Drawing Change Notice

CHANGE DOCUMENT NO.
24590-PTF-VDCN-MS-10-00008

JOB NO.	TITLE FOR CHANGE NOTICE
24590	UFP-VSL-00062B Redesign

JUSTIFICATION FOR CHANGE	CAUSE CODE
Based on the re-analysis of UFP-VSL-00062B, per calculation 24590-PTF-MVC-UFP-00023, for revised seismic conditions and design evolution, required a redesign of the vessel.	01 and 23

TYPICAL OUTER PJM SUPPORT
SCALE: 1/20
SEE DWG 24590-QL-POD-MVA0-00001-03-42
FOR REFERENCE BOM ITEMS

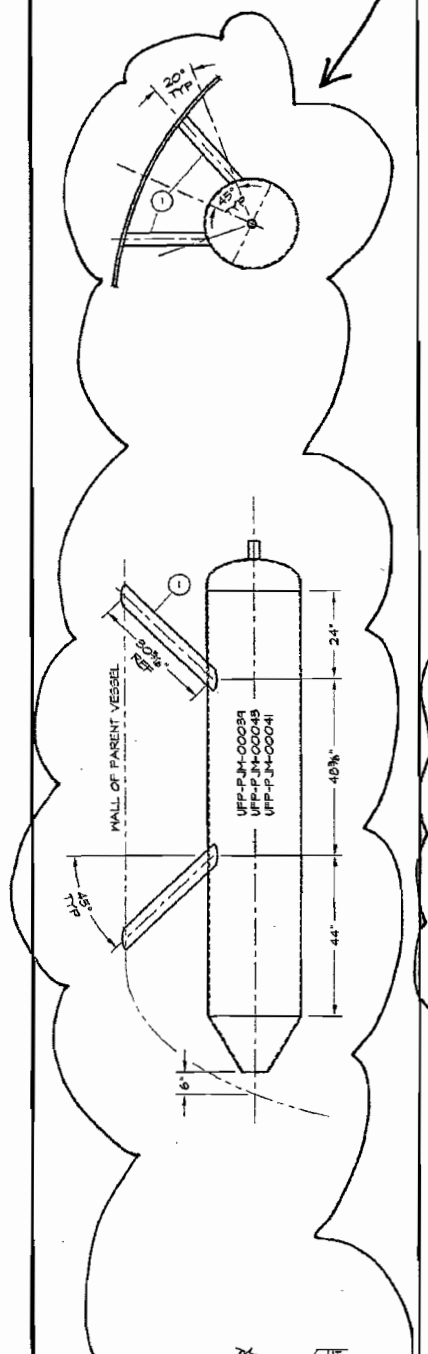
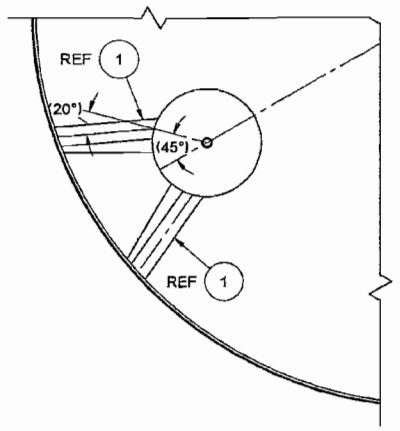
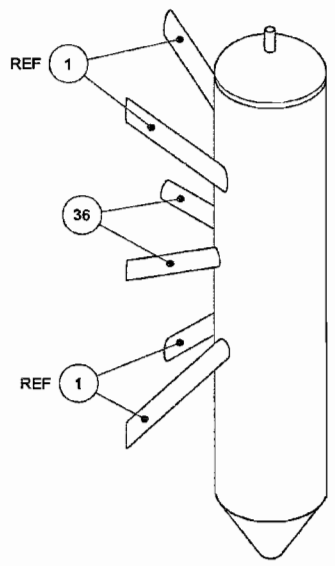
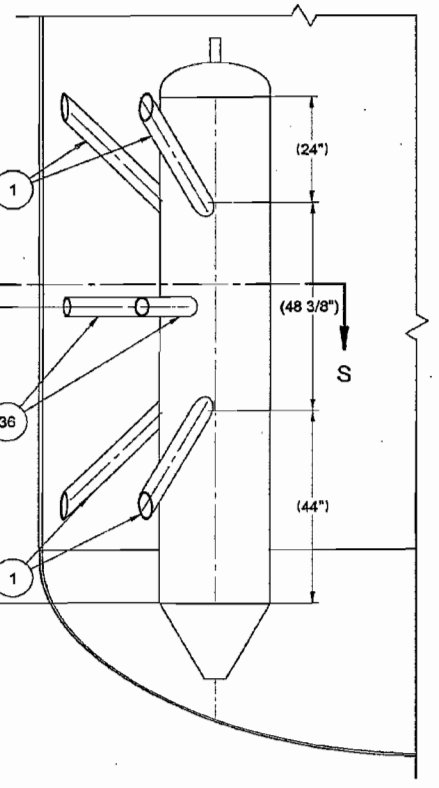
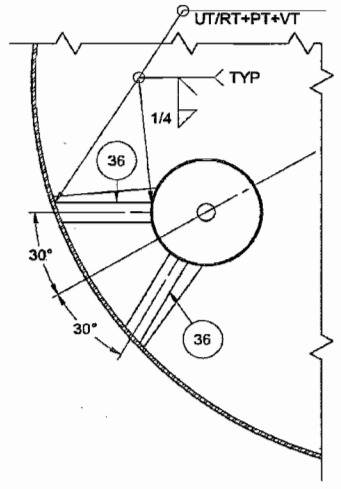
a.) Typical Outer PJM Pipe Support: Delete Typical Outer PJM Pipe Support view and replace with TYPICAL OUTER PJM SUPPORT, SECTION S-S and associated views shown on Attachment 1, page 16 of this VDCN.

30" CHARGE VESSEL & INNER PJM SUPPORT
SCALE: 1/20
SEE DWG 24590-QL-POD-MVA0-00001-03-42
FOR REFERENCE BOM ITEMS

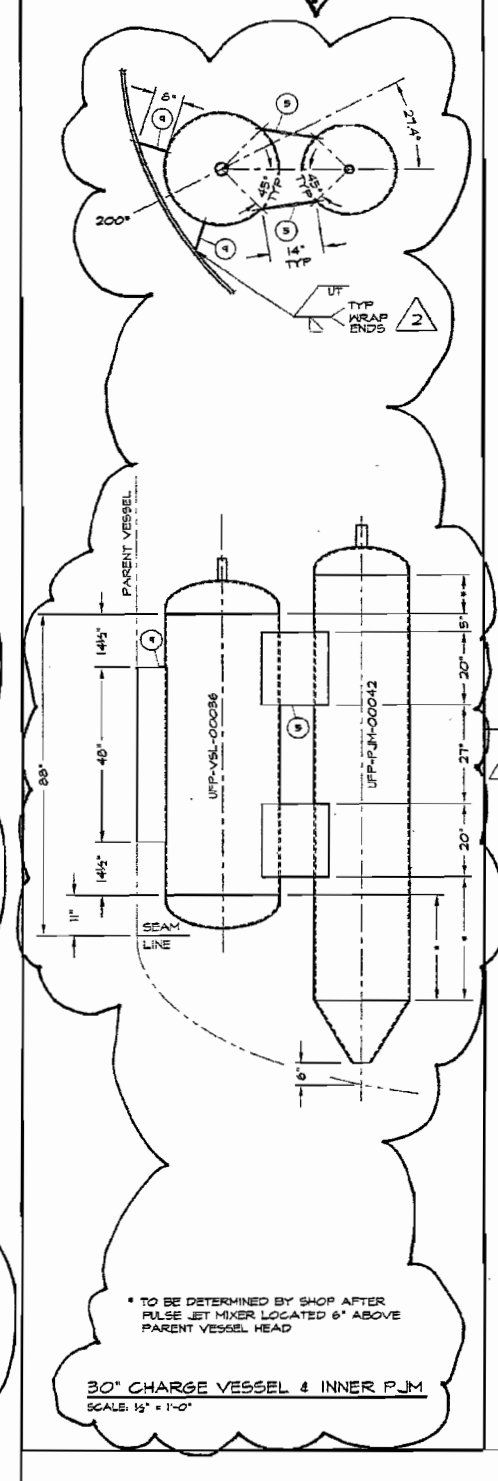
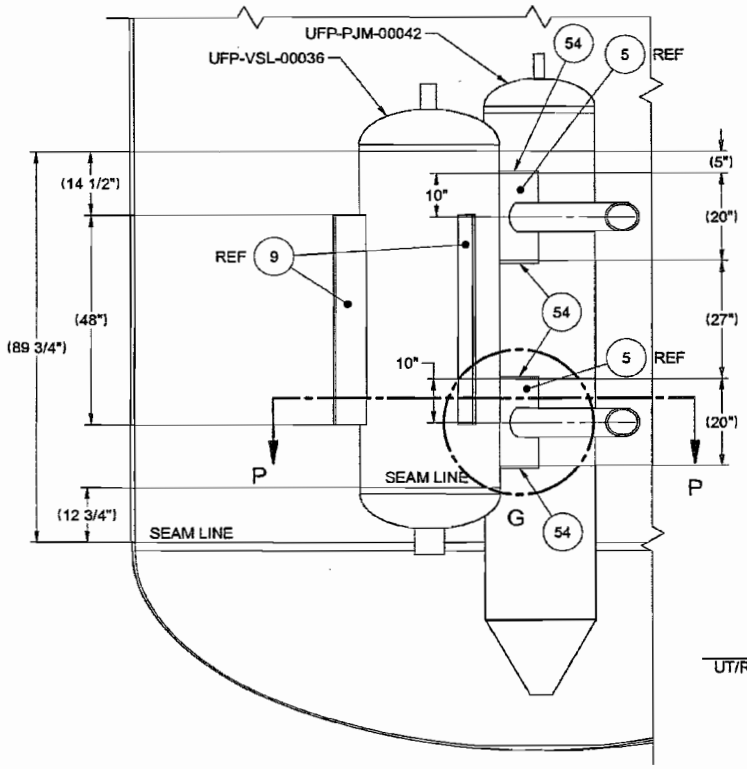
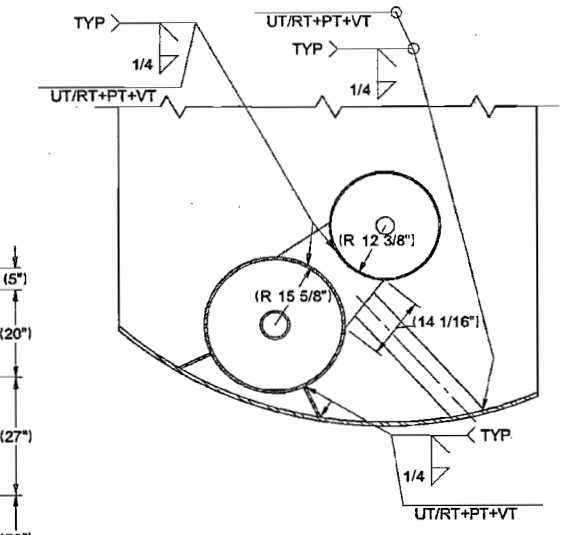
b.) 30" Charge Vessel & Inner PJM: Delete 30" Charge Vessel & Inner PJM view and replace with 30" CHARGE VESSEL & INNER PJM SUPPORT, SECTION P-P, item 54 DETAIL G and associated views shown on Attachment 1, page 14 of this VDCN.

VIEW A
36" CHARGE VESSEL & INNER PJM SUPPORT
SCALE: 1/20
SEE DWG 24590-QL-POD-MVA0-00001-03-42
FOR REFERENCE BOM ITEMS

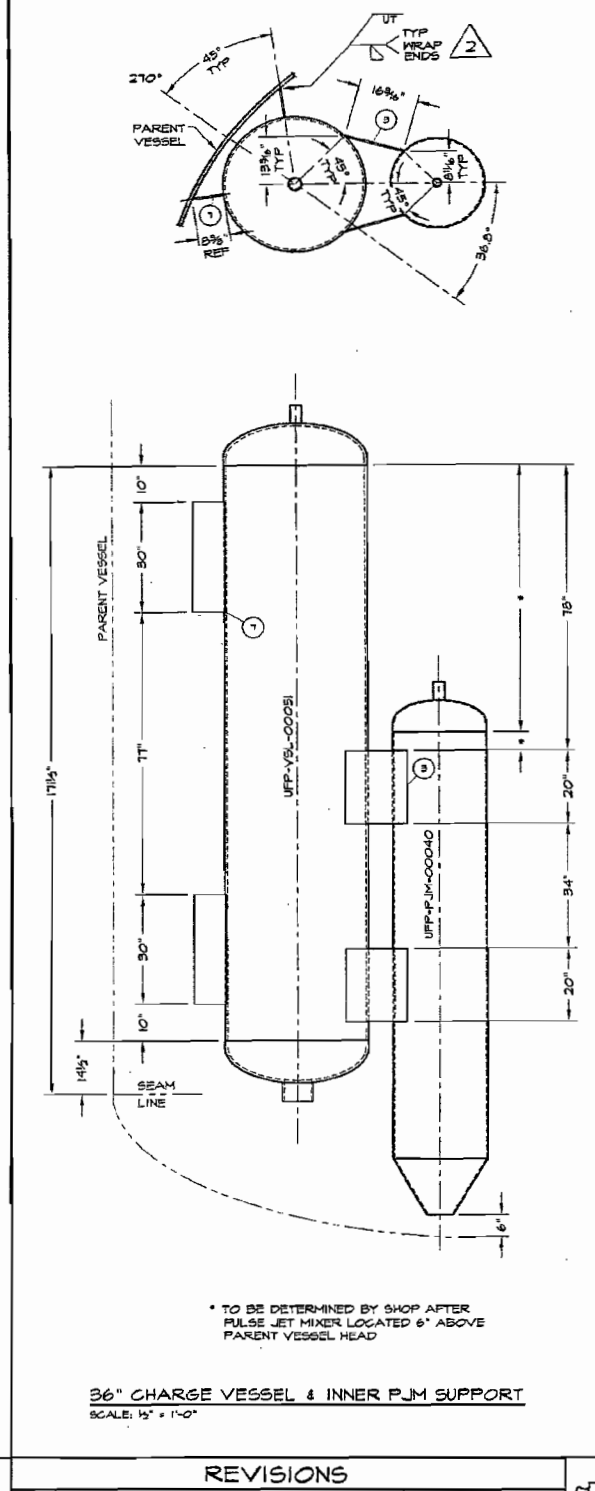
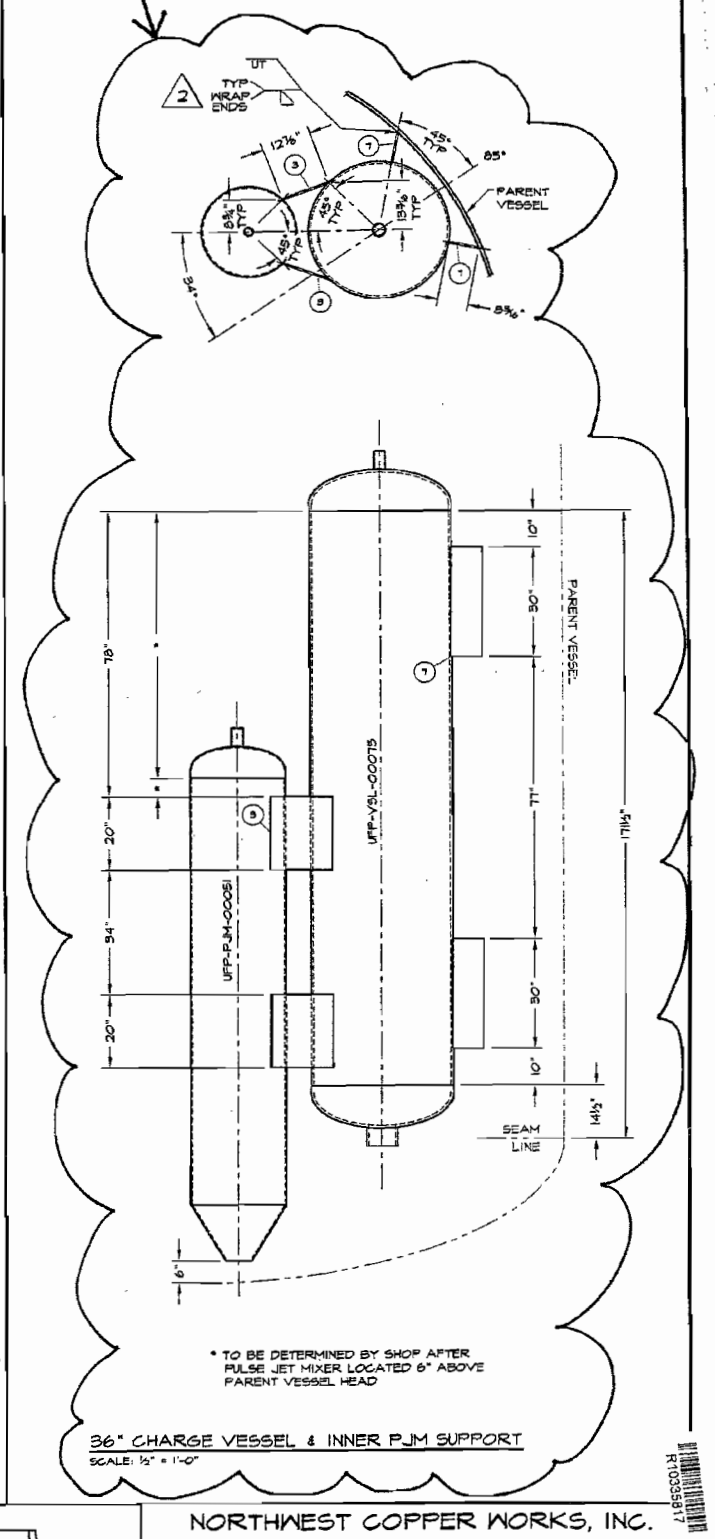
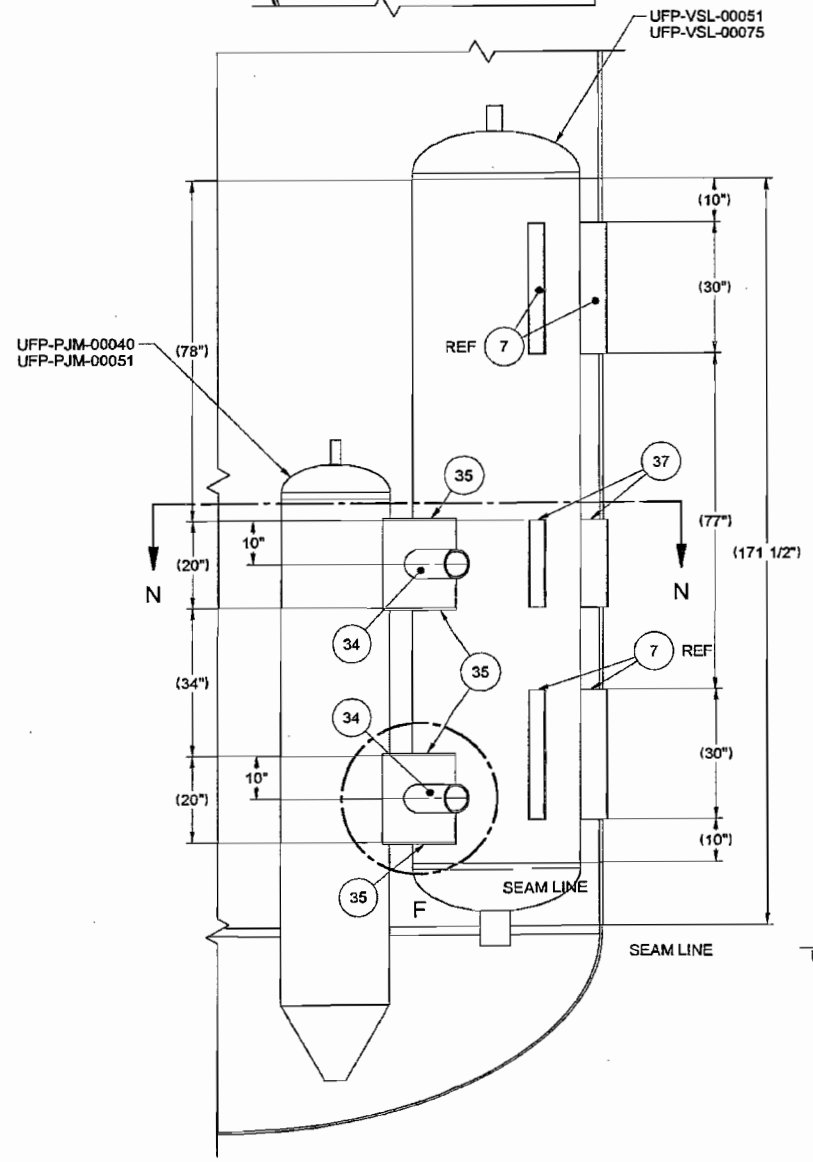
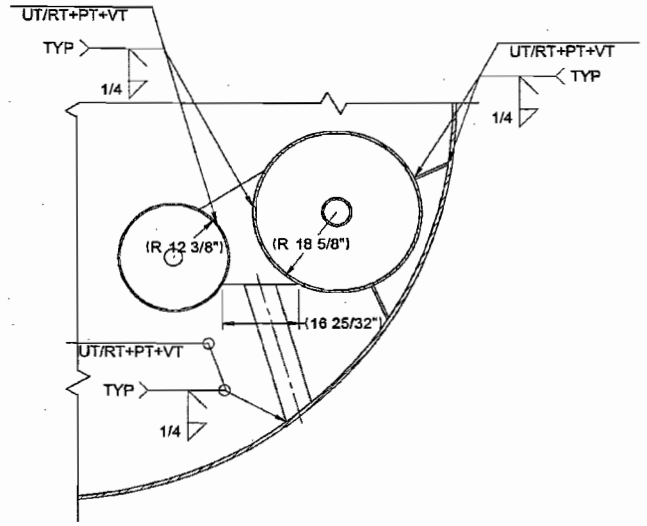
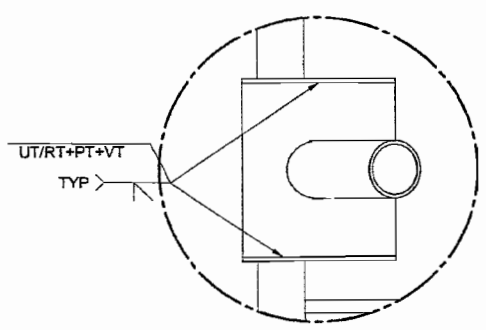
c.) 36" Charge Vessel & Inner PJM Support: Delete 36" Charge Vessel & Inner PJM Support and replace with VIEW A 36" CHARGE VESSEL & INNER PJM SUPPORT, SECTION N-N, item 35 DETAIL F, and associated views shown on Attachment 1, page 14 of this VDCN.

2 36" CV DELIVERY RFD PUMP DETAIL
SCALE: 1" = 1'-0"

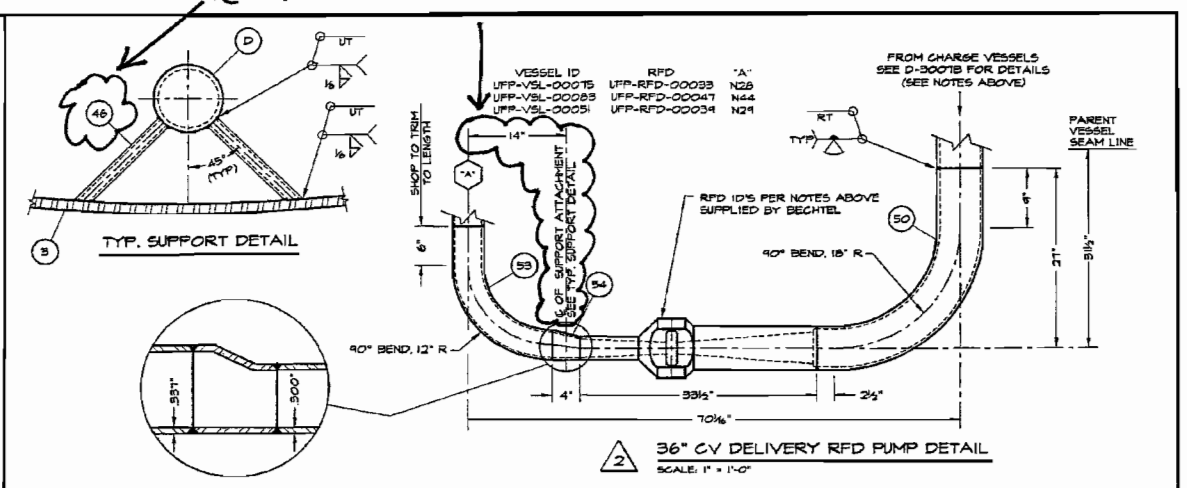
a.) 36" CV Delivery RFD Pump Detail: Remove support item 46 from TYP SUPPORT DETAIL and reference to SEE TYP SUPPORT DETAIL including dimension.

2 30" CV DELIVERY RFD PUMP DETAIL
SCALE: 1" = 1'-0"

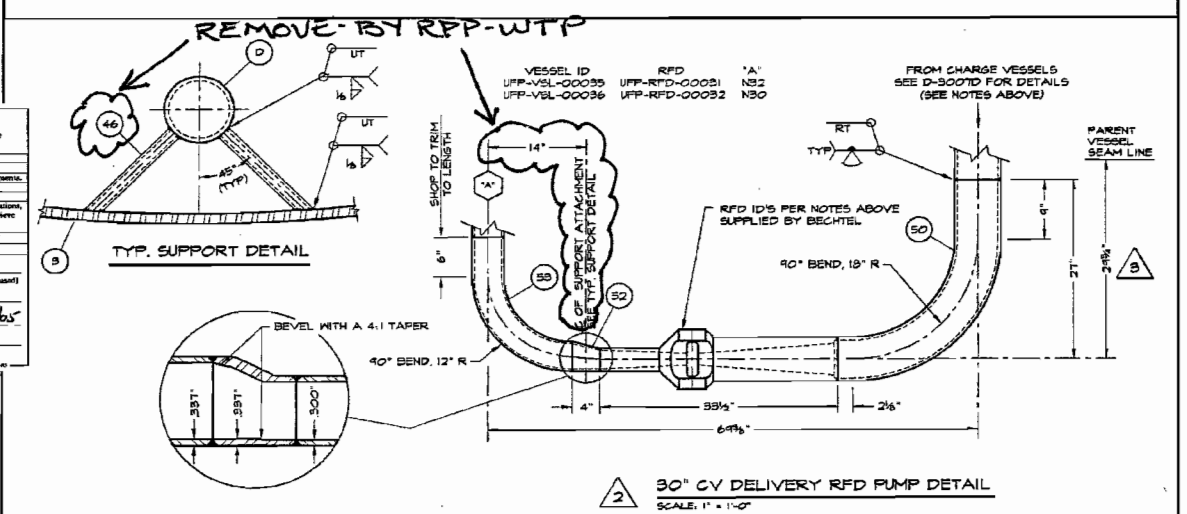
b.) 30" CV Delivery RFD Pump Detail: Remove support item 46 from TYP SUPPORT DETAIL and reference to SEE TYP SUPPORT DETAIL including dimension.

2 SAMPLER RFD PUMP DETAIL
SCALE: 1½" = 1'-0"

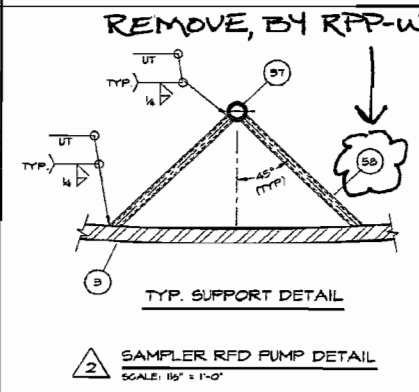
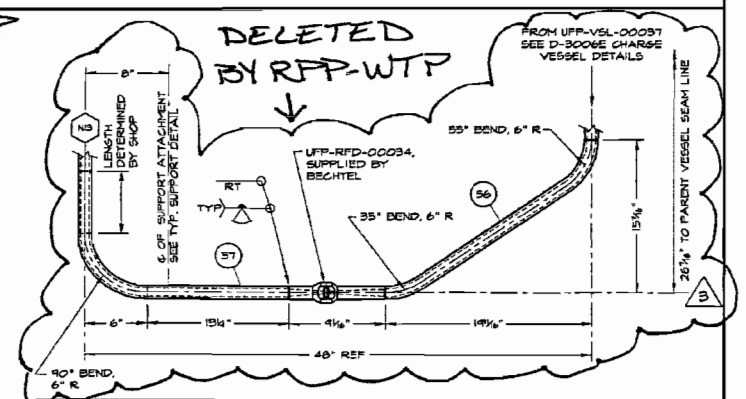
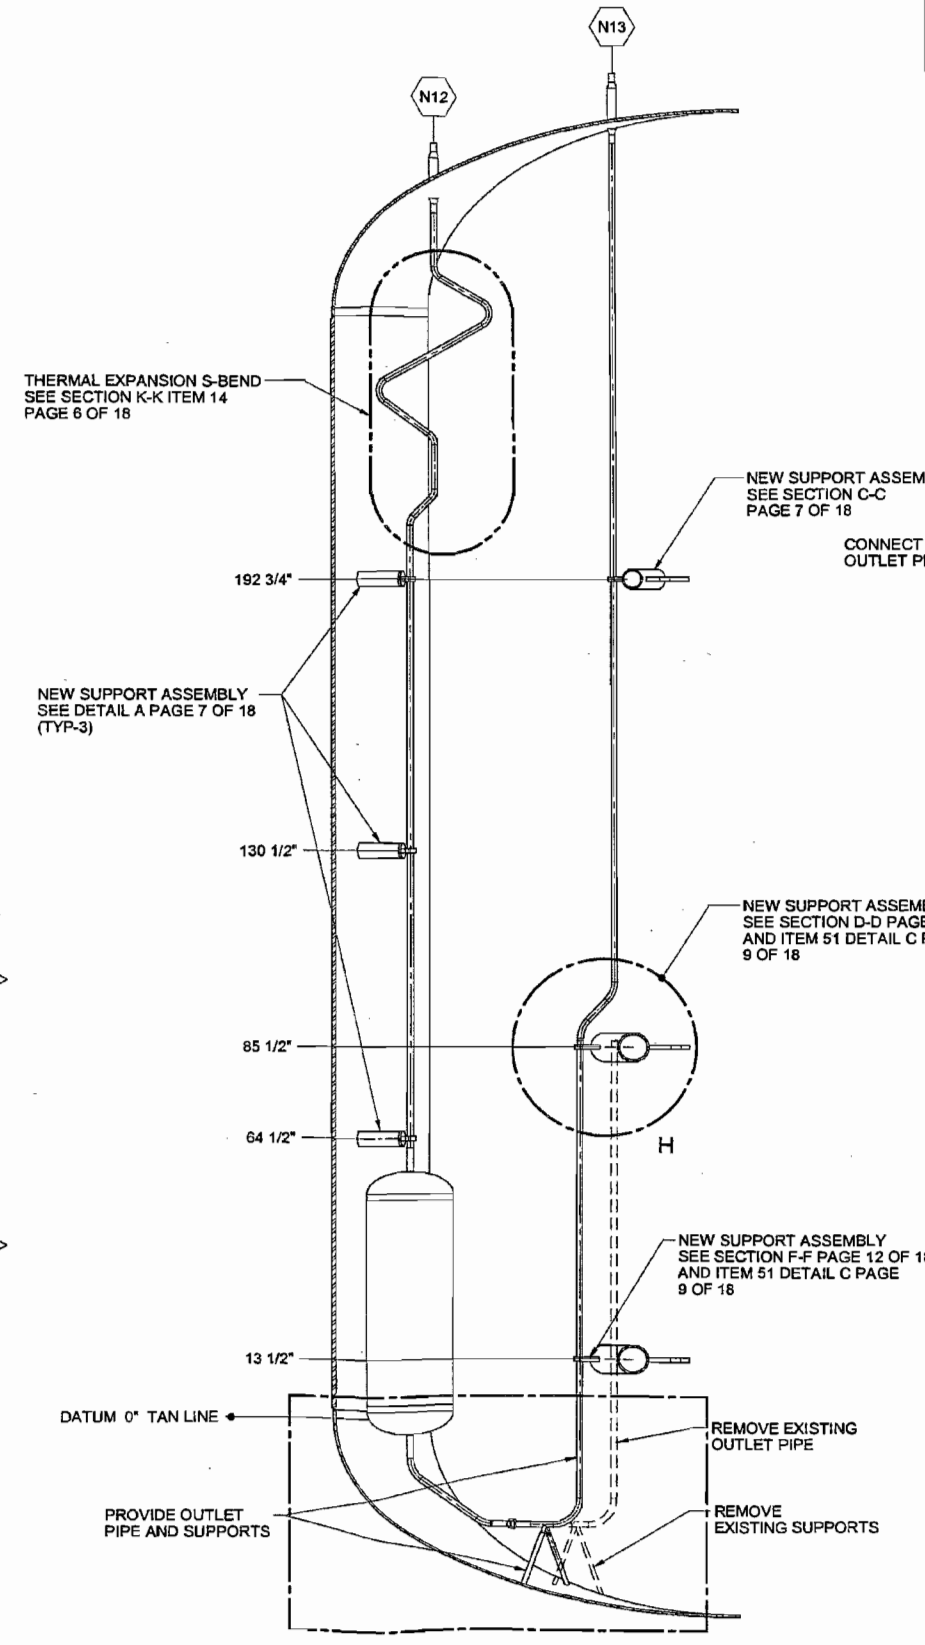
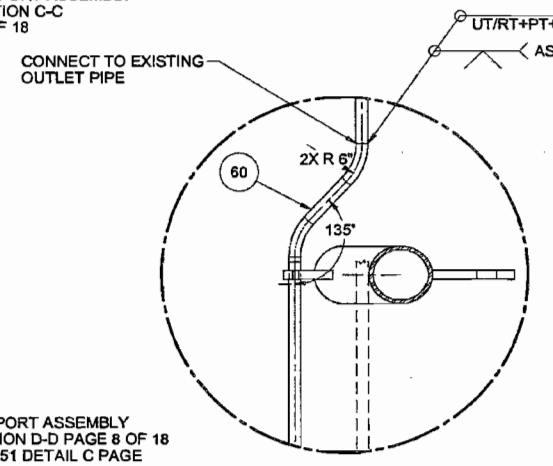
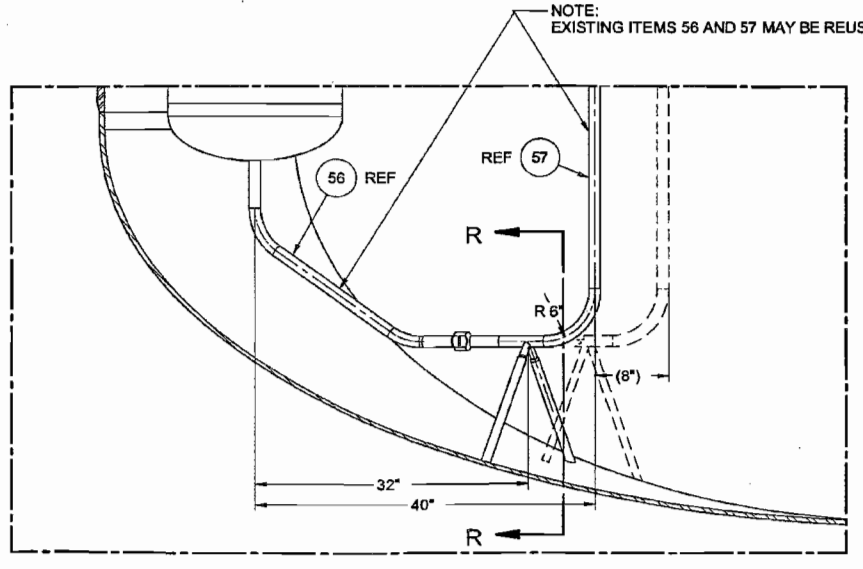
c.) Sampler RFD Pump Detail:

(1.) Remove support item 58 from TYP SUPPORT DETAIL.

(2.) Add DETAIL J, SECTION R-R, and SAMPLER PUMP RFD DETAIL shown on Attachment 1, page 16 of this VDCN.

(3.) Delete Sampler detail and replace with SAMPLER PUMP RFD ASSEMBLY and DETAIL H shown on Attachment 1, page 16 of this VDCN.

2" SCH 80 INLET TO INTERNALS
SCALE: ¾" = 1"
N34 N35 N36

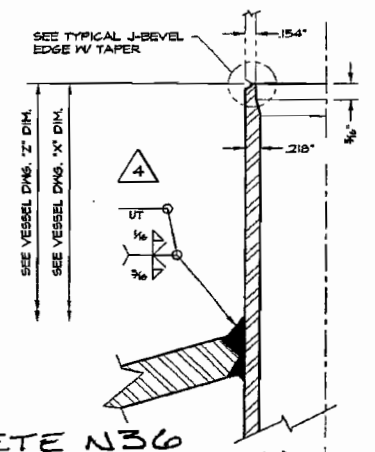
9. **Affected Document: 24590-QL-POD-MVA0-00001-03-33 (see Attachment 1, page 17 of this VDCN).**
   a.) 2"SCH 80 INLET TO INTERNALS: Delete N36 and replace with Typical SCH 160 Nozzle Detail (REF Section Q-Q).
   b.) Under title block, delete BNI reference drawing entitled, "REF DWG 24590-PTF MV-UFP-00006 REV 0".

DELETE N36 AND REPLACE WITH TYPICAL SCH 160 NOZZLE DETAIL (REF SECTION Q-Q) BY RPP-WTP →
